REQUEST FOR INFORMATION DATE: February 21, 2017 NO.: RFI-452

Project Name: 15051-Webster University Interdisciplinary Science Building Project No.: 15051

Subject: north courtyard stair wall dimensions

RETAINING WALL AND SOUTH SIDE OF STEPS AT THE WEST COURTYARD STAIR

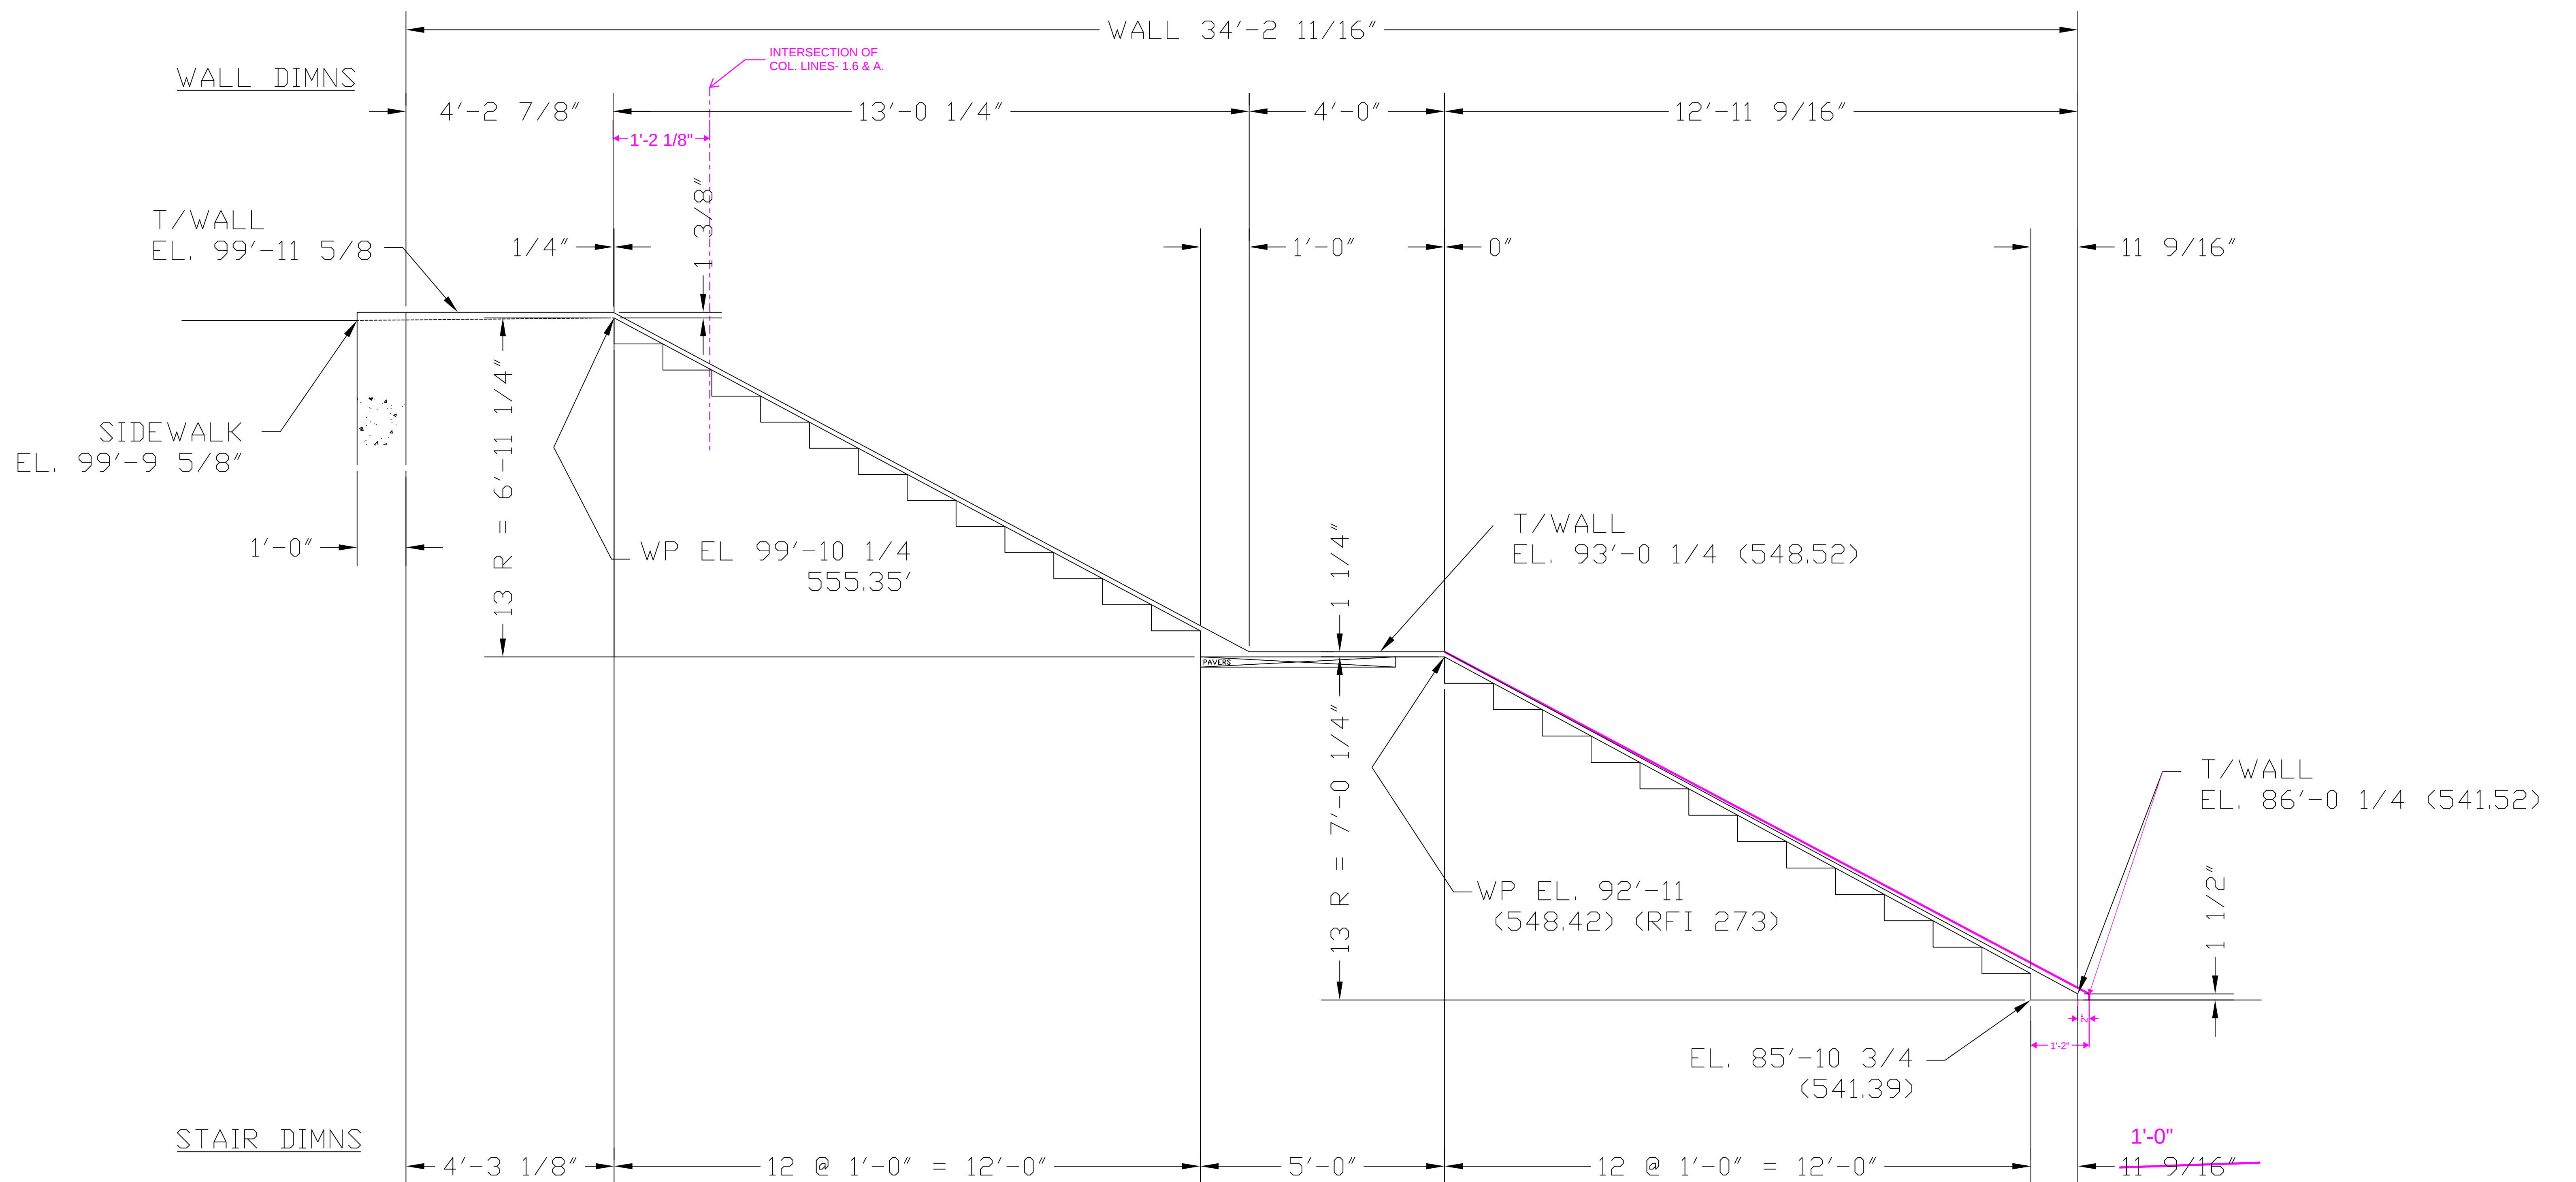
1. Please provide the dimension to the bottom of this wall (shown on A0508.C) based off of a grid line.
2. Per the attached shop drawing it appears the top of wall elevation 541.42 will not work with the run of the wall. Please advise correct dimensions/elevations to remain ADA compliant.

As discussed, see markups.
